ZONING CHANGE REVIEW SHEET

CASE: C814-2007-0009.01 **P.C. DATE:** May 13, 2014
 The Terrace in Oak Hill Planned Unit Development
 (formerly West 71 Office Park Planned Unit Development)

TO: Dave Anderson, Chairperson
Members of the Planning Commission

SUBJECT: Terrace in Oak Hill (Formerly called West 71 Office Park)
Planned Unit Development Ordinance Number 20070726-104

EXHIBIT D-2

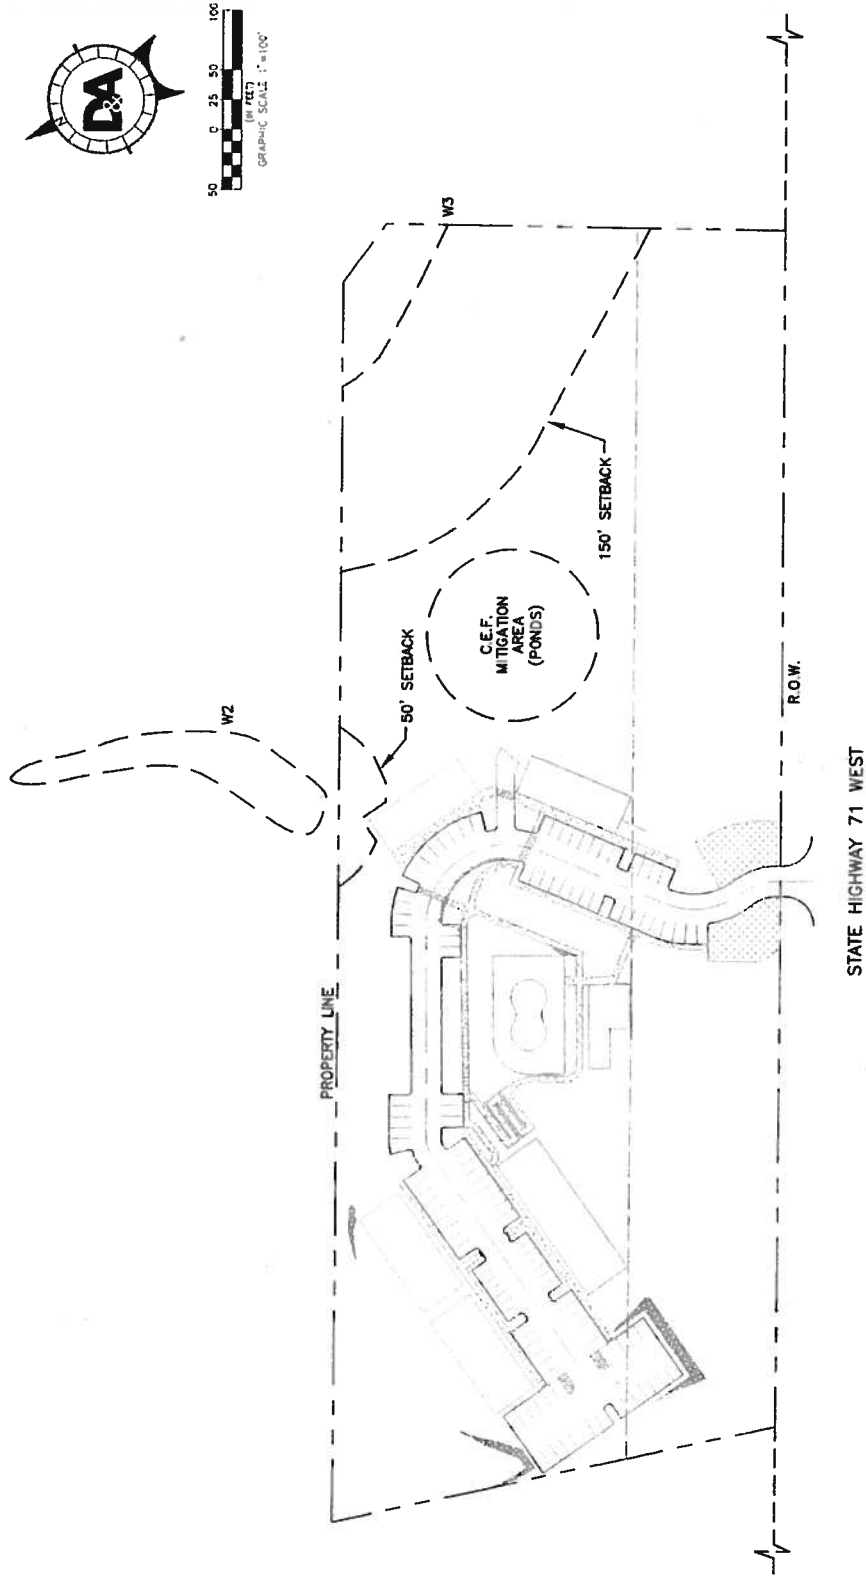
The current proposal carries forward the grant to reclassify the Williamson Creek WQTZ to Uplands Zone (see Exhibit D-2). The underlying logic remains the same – that the site does not drain to Williamson Creek. There is still WQTZ and CWQZ acreage on site, but it pertains to the unnamed tributary along the northeastern corner. As proposed, the amended PUD would contain 0.75 acres of WQTZ and 0.38 acres of CWQZ, totaling 1.13

Therefore, the applicant proposes to revise the Critical Water Quality Zone and Water Quality Transition Zone of the unnamed waterway located at the northeast corner of the property (Exhibit D-2 WQTZ Reclassified and Exhibit D-3 CWQZ Reclassified) to reflect current GIS data. This revision will not alter the language of the approved PUD Ordinance; but will require a revision of Land Use Plan associated with the PUD Ordinance (Exhibit C-1 Proposed Land Use Plan and Exhibit C-2 Proposed Land Use Notes).

AREA OF WOTZ TO BE RECLASSIFIED
 ORIGINAL PUD : 3.34 AC. (145,490 S.F.)
 NEW PUD : 3.57 AC. (155,490 S.F.)
 DIFFERENCE = .23 AC. (10,000 S.F.)

AREA OF WOTZ
 ORIGINAL PUD : 0.85 AC. (41,382 S.F.)
 NEW PUD : 0.75 AC. (32,670 S.F.)
 DIFFERENCE = 0.20 AC. (8,712 S.F.)

EXHIBIT D-4

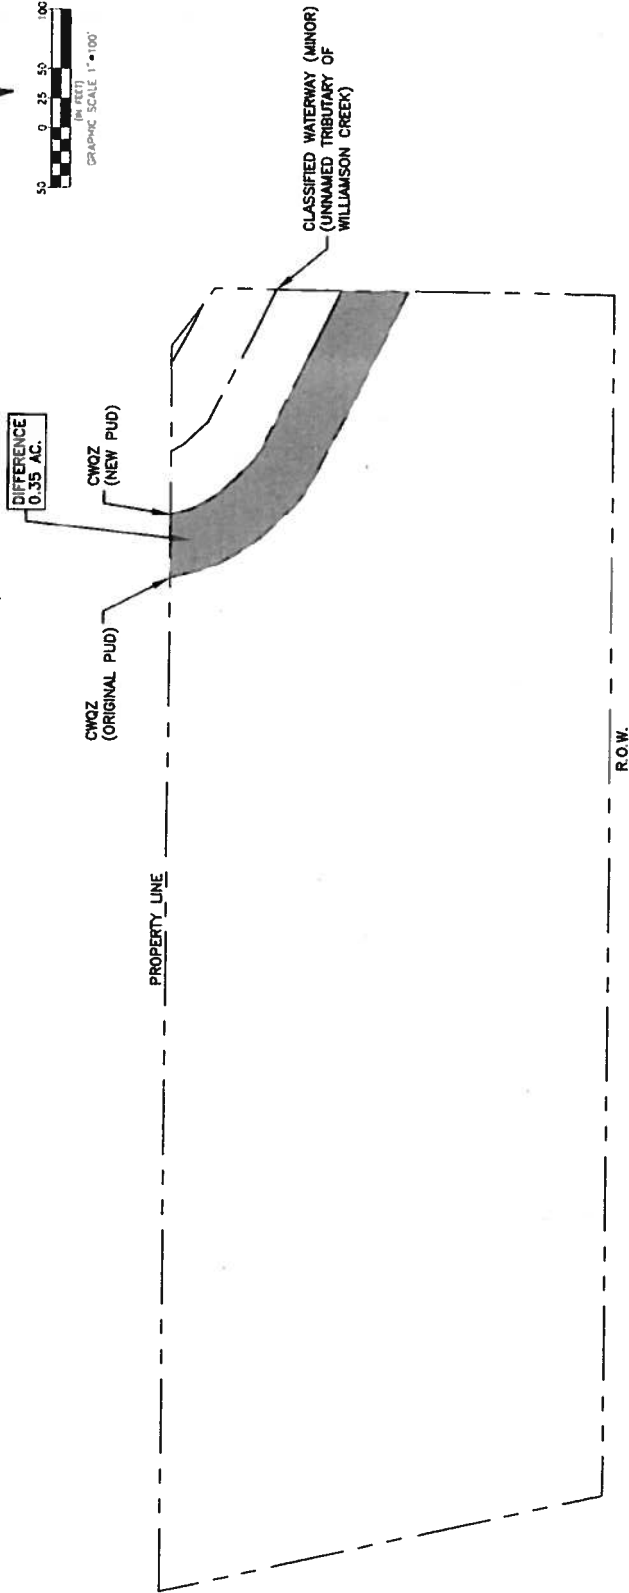
Lastly, the PUD amendment would allow for additional cut-and-fill between 4 feet and 8 feet (see Exhibit D-4), allow for additional impervious cover on moderate slopes (see Exhibit D-5), allow for the realignment of Water Quality Transition and Critical Water Quality Zones in the northeast corner of the site as noted above (see Exhibit D-2 & D-3), and allow for modification of the standard setback from an offsite wetland critical environmental feature (Exhibit D-1).

~~The proposed development requires grading up to 8 feet due to existing topography. In general, grading is limited to 4 feet². The applicant is seeking to amend the approved PUD Ordinance to allow grading up to 8 feet not associated with building foundation construction or water quality / detention pond construction (Exhibit D-4 Cut and Fill). The applicant withdrew this request at Planning Commission on May 13, 2014~~

TOTAL CUT/FILL
BETWEEN 4' AND 8'
WILL NOT EXCEED
5,000 SF

- NOTES:
1. DOES NOT INCLUDE CUT/FILL BENEATH BUILDING FOUNDATIONS.
 2. CUT/FILL LIMIT DOES NOT APPLY TO WATER QUALITY/DETENTION POND CUT/FILL DEPTH OR VOLUME.

EXHIBIT D-5

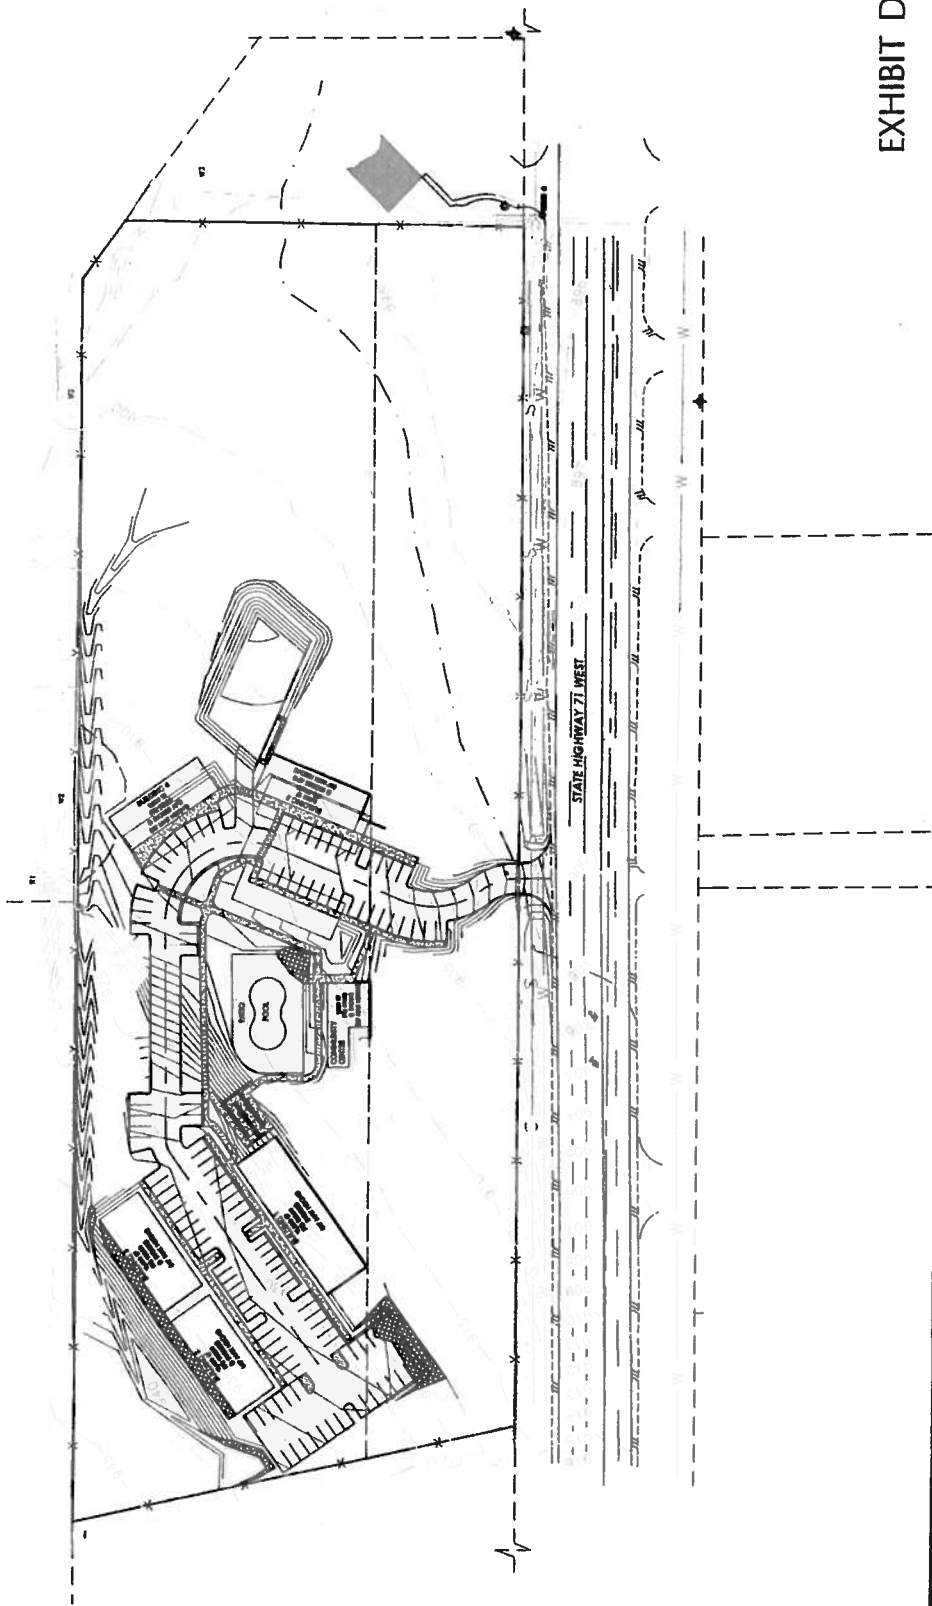
- The **allowable impervious cover** on slopes from 15 to 25% is **0.025 acres** (approximately 1,091 square feet).
- Under the revised PUD, the **proposed impervious cover** on slopes from 15 to 25% **will not exceed 0.11 acres** (approximately 4,792 square feet).

- The **allowable impervious cover** on slopes from 25 to 35% is **0.02 acres** (approximately 870 square feet).
- Under the revised PUD, the **proposed impervious cover** on slopes from 25 to 35% **will not exceed 0.07 acres** (approximately 3,049 square feet).

3. Total impervious cover on slopes from 15% to 35% will be limited as follows:
 - Impervious cover on slopes from 15 to 25% will not exceed 0.11 acres (approximately 4,792 square feet).
 - Impervious cover on slopes from 25 to 35% will not exceed 0.07 acres (approximately 3,049 square feet).
 - Construction on slopes will be permitted as generally displayed on Exhibit D-5 Slopes.
4. The revised downstream buffer will increase from approximately 3.37 acres to approximately 3.75 acres.

- Impervious cover on slopes from 25 to 35% will not exceed 0.07 acres (approximately 3,049 square feet).
 - Construction on slopes will be permitted as generally displayed on Exhibit D-5 Slopes.
4. The revised downstream buffer will increase from approximately 3.37 acres to approximately 3.75 acres.
 5. The PUD Ordinance or Land Use Plan must specify that no hard surface trails are permitted in the downstream buffer. Trails are permitted in the downstream buffer provided that the trails are constructed of permeable materials installed over non-compacted base.

EXHIBIT D-6

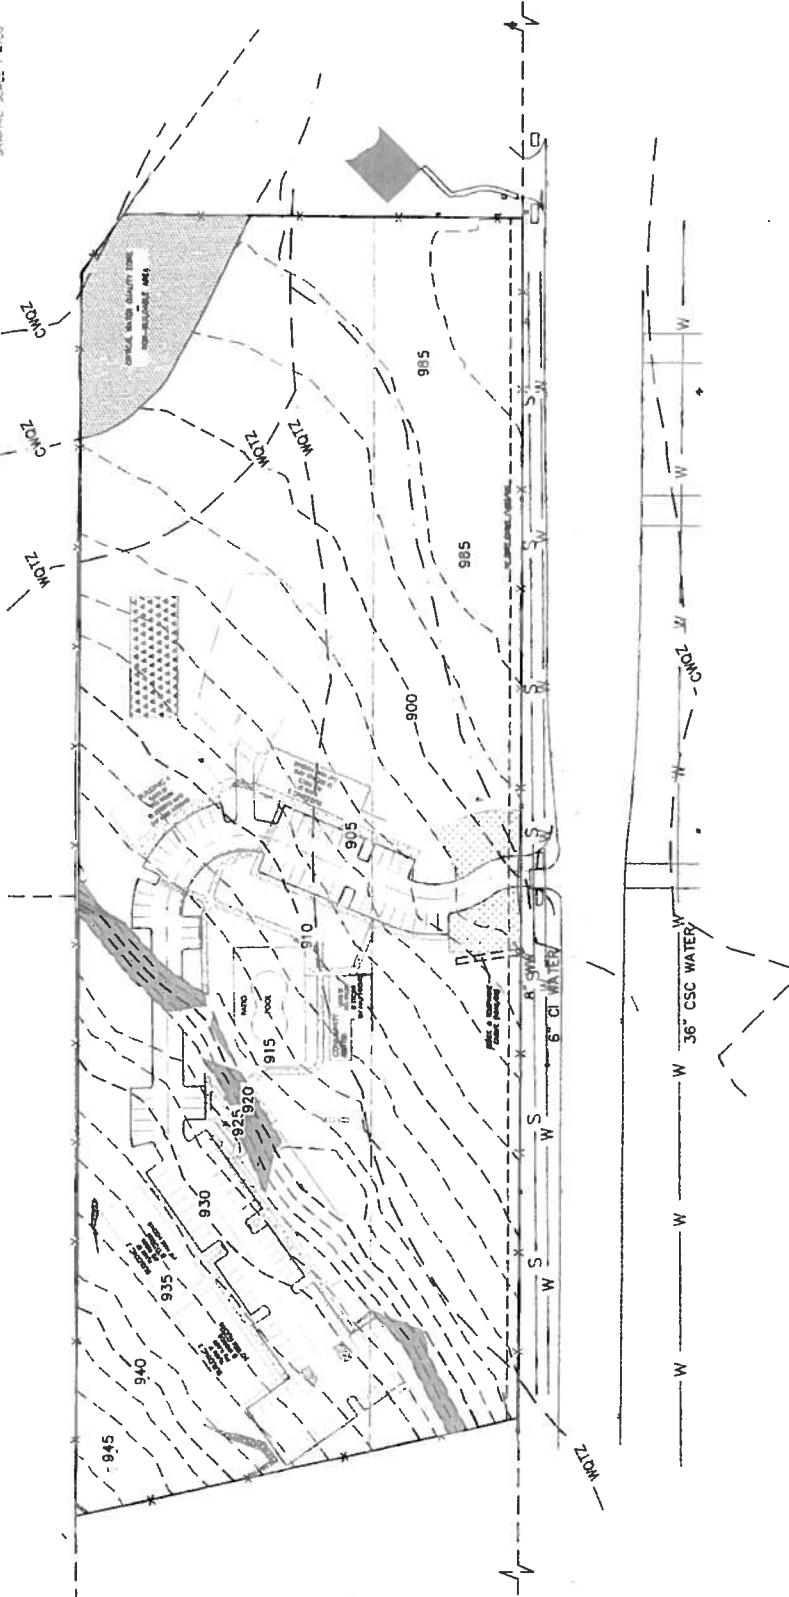
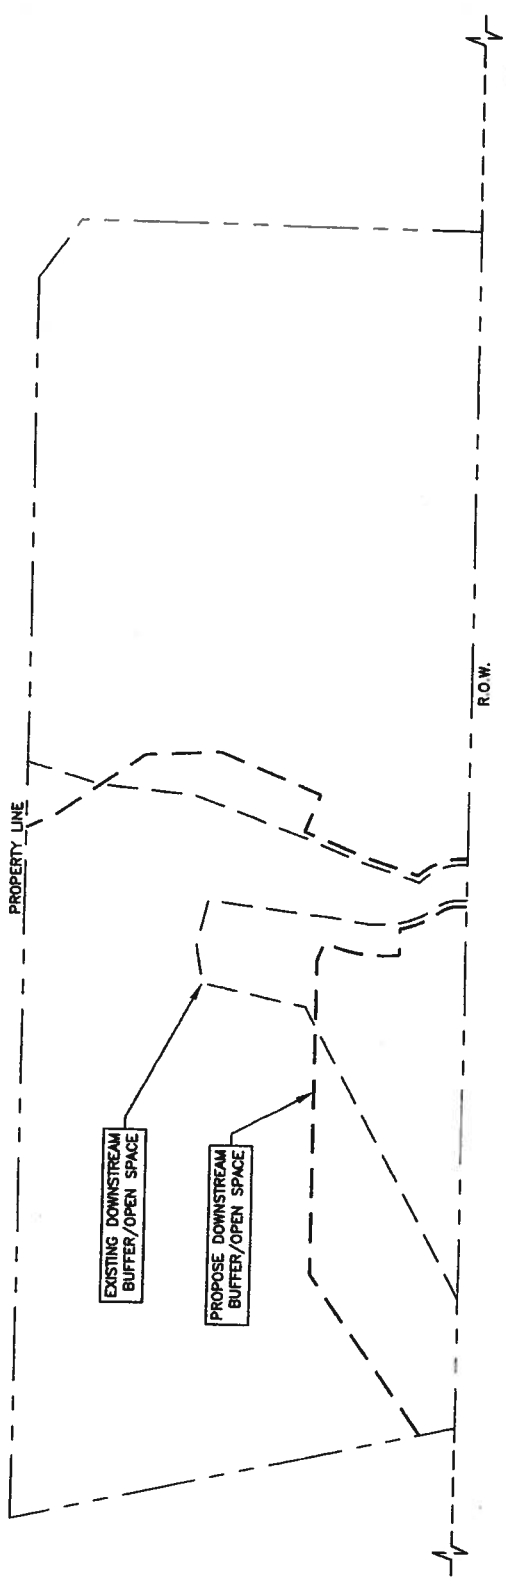
The downstream buffer area is carried forward in the proposed amendment, and in fact, is enlarged by at least 0.4 acres. As currently envisioned, the buffer area would be 3.75 acres (see Exhibit D-6). Acknowledging that this buffer area might be modified as the final site plan is developed, the minimum area of the buffer would be 3.745 acres, but it could potentially be enlarged further. That minimum acreage still represents a 12.28% increase over the existing PUD's downstream buffer area. The utility connections, drainage facilities, and permeable walking trails proposed in the buffer area are either already allowed in the PUD or allowed by current code. There is no expansion of the permitted infrastructure uses, but there is a clarification of PUD verbiage in light of uses specified in the existing PUD; nonetheless, this area is to remain largely in its natural and undisturbed state.

EXISTING DOWNSTREAM BUFFER/OPEN SPACE = 3.37 AC.
 PROPOSED DOWNSTREAM BUFFER/OPEN SPACE = 3.75 AC.
